## STAFF RECOMMENDATION 1005 Mansfield Street May 15, 2019

**Application:** New Construction—Preliminary SP  
**District:** Maxwell Heights Neighborhood Conservation Zoning Overlay  
**Council District:** 05  
**Base Zoning:** RS5  
**Map and Parcel Number:** 08208039800  
**Applicant:** Wojtek Krupka  
**Project Lead:** Melissa Baldock, [Melissa.Baldock@nashville.gov](mailto:Melissa.Baldock@nashville.gov)

**Description of Project:** A detached accessory dwelling unit is requested on this single-family zoned lot via an SP rezoning. (2019SP-038-01) The rezoning request is currently on the Planning Commissions May 23, 2019 agenda.

**PLOT PLAN**

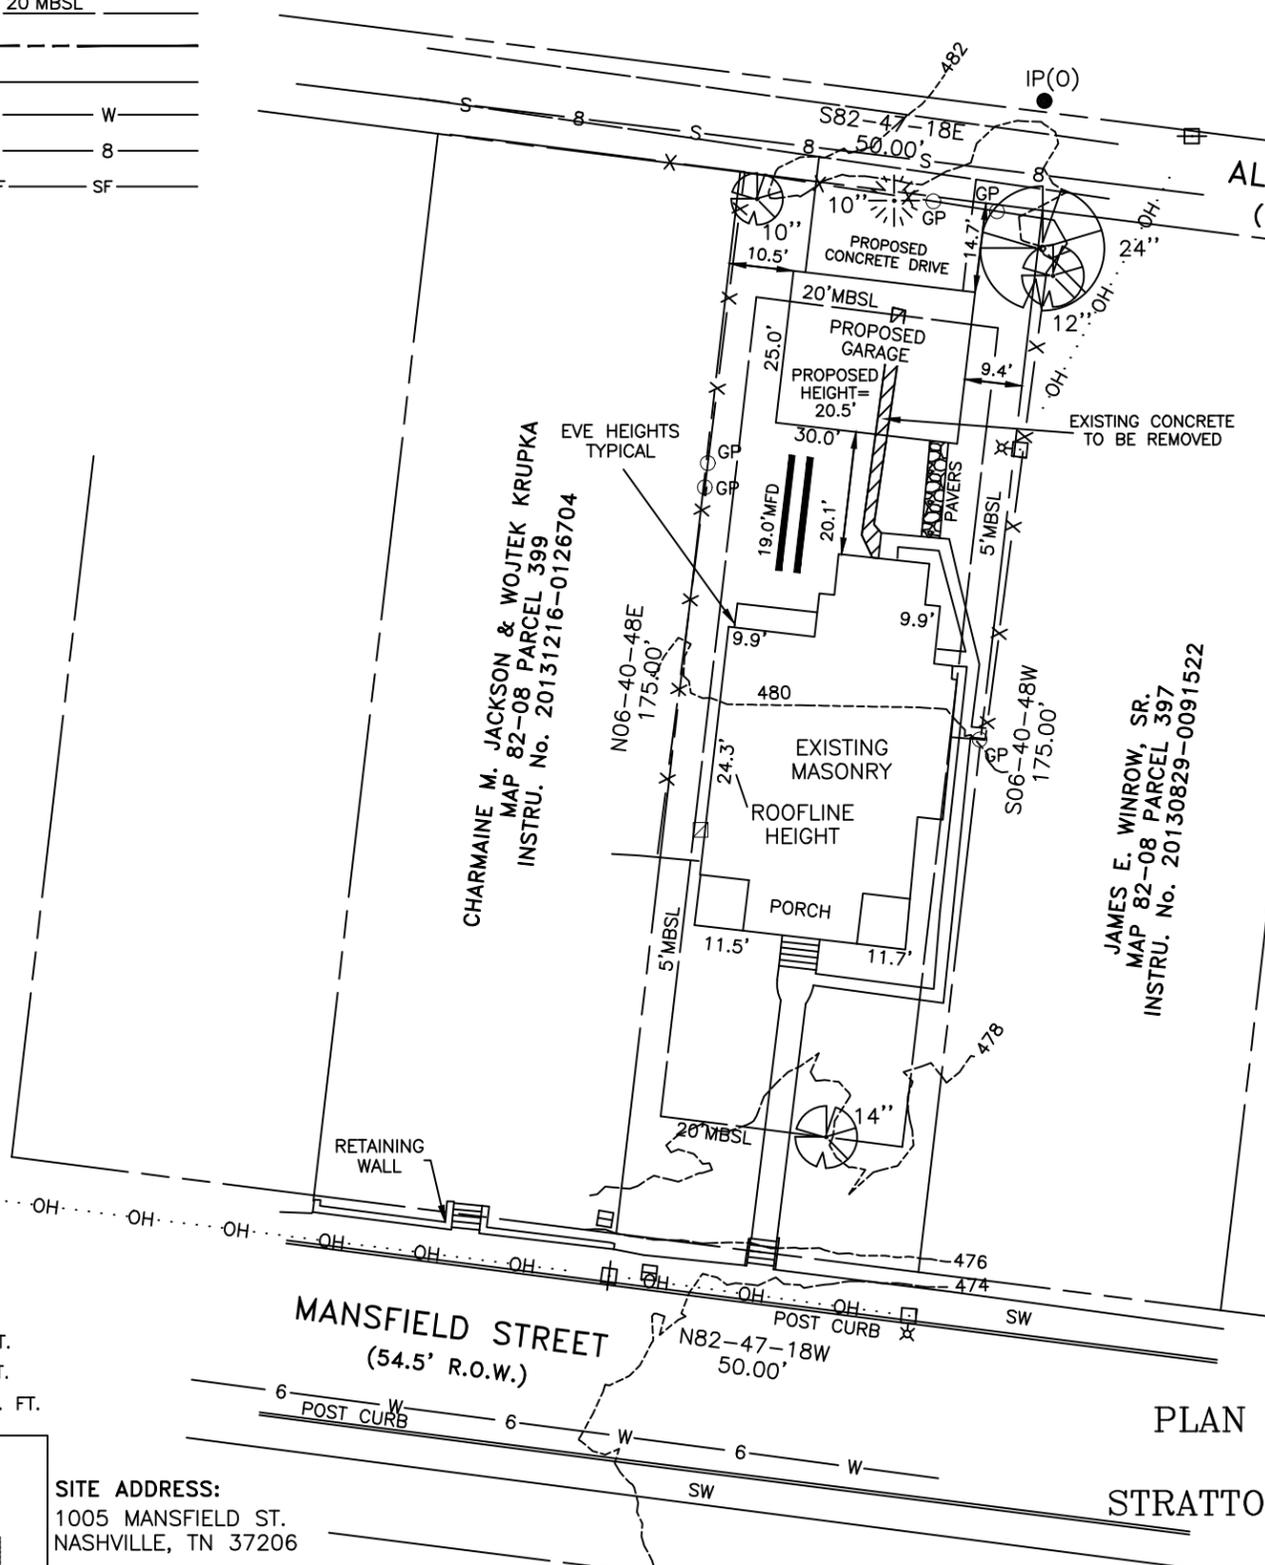
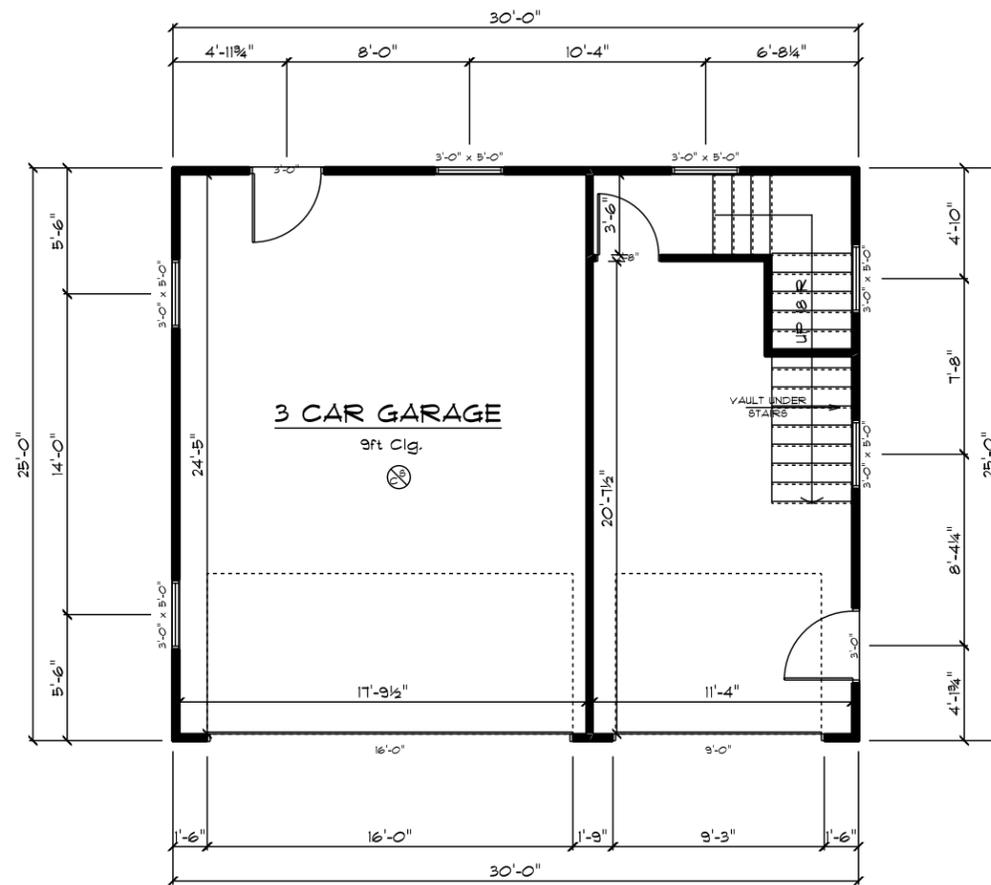
<b>MINIMUM</b>	<b>PROPOSED</b>
<b>Space between principal building and DADU/Garage</b>	20'	20.1'
<b>Rear setback</b>	5'	14.7'
<b>L side setback</b>	5'	10.5'
<b>R side setback</b>	5'	9.4'
<b>How is the building accessed?</b>	From the alley or existing curb cut	Alley

The proposed outbuilding meets the setbacks established by MHZC for outbuildings. Staff finds that the outbuilding meets the setback and site planning requirements of section II.B.1.i. of the design guidelines.

**2ND FLOOR PLAN**

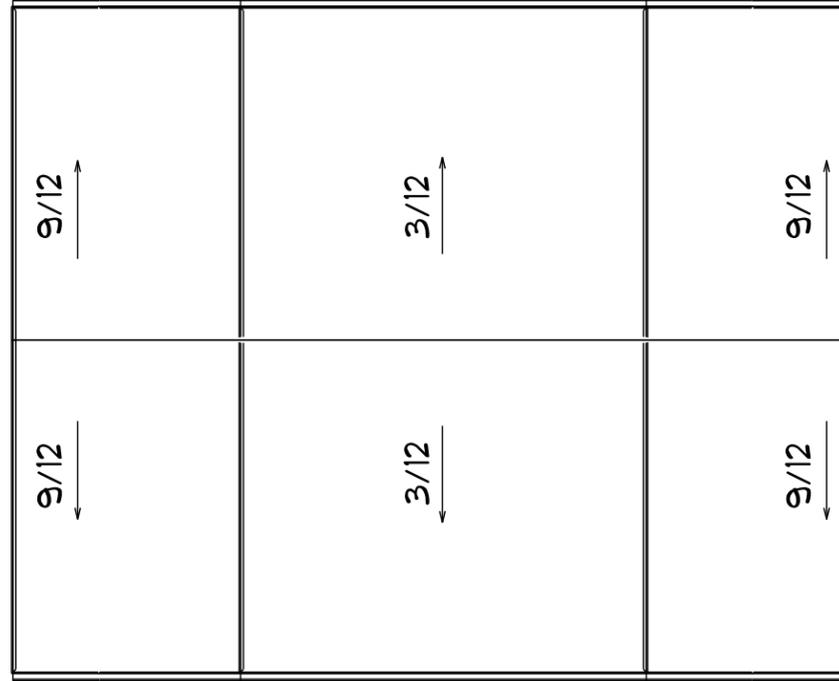
\*The elevations show that the proposed dormers are stepped back two feet (2') from the wall below. However, the second floor plan and the roof plan do not show the dormers as inset the required two feet (2'). In order to meet the design guidelines, the dormers must be inset two feet (2'). Staff there recommends receipt of a revised second floor and roof plan showing the dormer inset of two feet (2').

1. The applicant submit revised second floor and roof plans showing the dormers as inset two feet (2') from the wall below; and
2. MHZC staff approve the final choices for all windows and doors prior to purchase and installation.
